BURLINGTON DEVELOPMENT REVIEW BOARD

BURLINGTON DEVELOPMENT REVIEW BOARD Wednesday August 17, 2016, 5:00 PM Contois Auditorium, City Hall, 149 Church Street, Burlington, VT AMENDED AGENDA

- 1. 16-1490SD; 349 South Willard (RL, Ward 6S) Gardenview Associates, Inc.**
Proposed subdivision of property into two lots. (Project Manager, Ryan Morrison)
- 2. 16-1145CA/MA; 207 Flynn Ave (ELM, Ward 5S) City Market/Onion River Co-op**
Construct new retail grocery building and related site improvements and subdivide lot.
(Project Manager, Scott Gustin)

PROPOSED
OVERALL
SITE PLAN

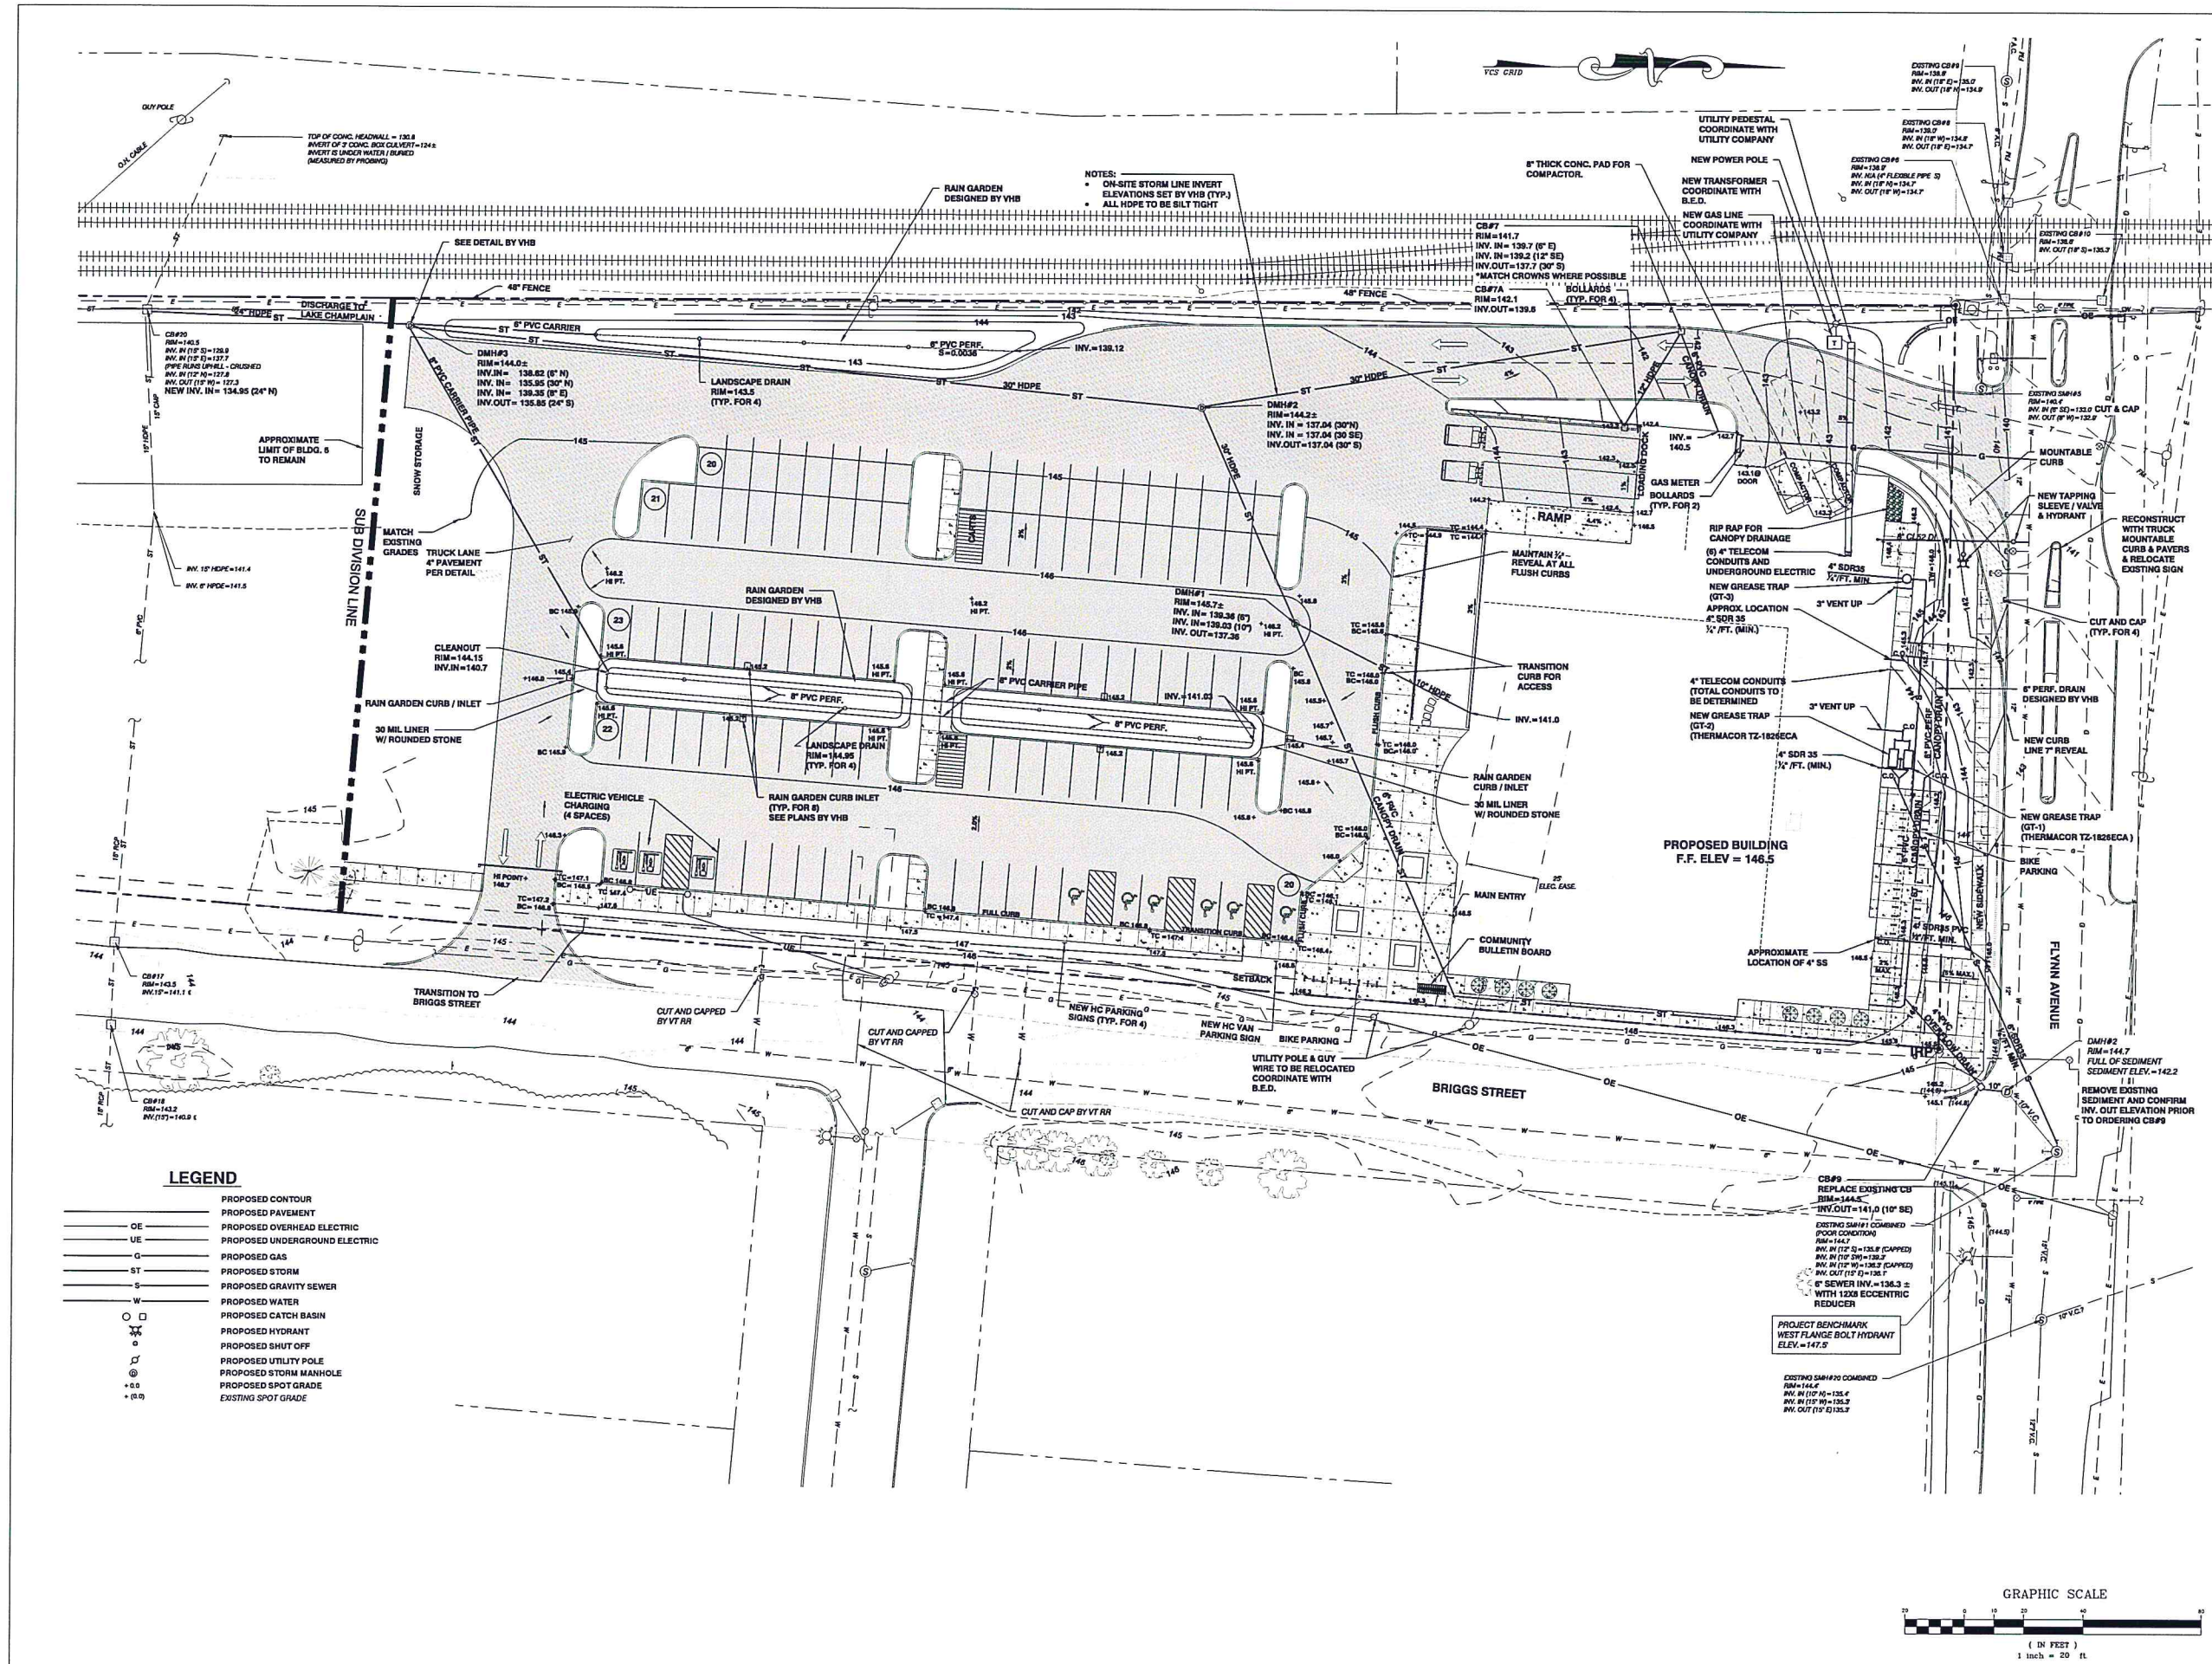
- **City Market Driveway Access Width**-Within the current site plan the Flynn Avenue Driveway apron is very broad and wide to accommodate commercial truck traffic. This broad apron is precipitated by the commercial delivery vehicles and the geometric limitations of the roadway with the existence of a center median for the adjacent rail crossing. We would ask that City Market consult with the City of Burlington/VTRANS Rail/Federal Rail Administration to determine if this center median can be abbreviated or relocated to allow a less broad driveway apron.
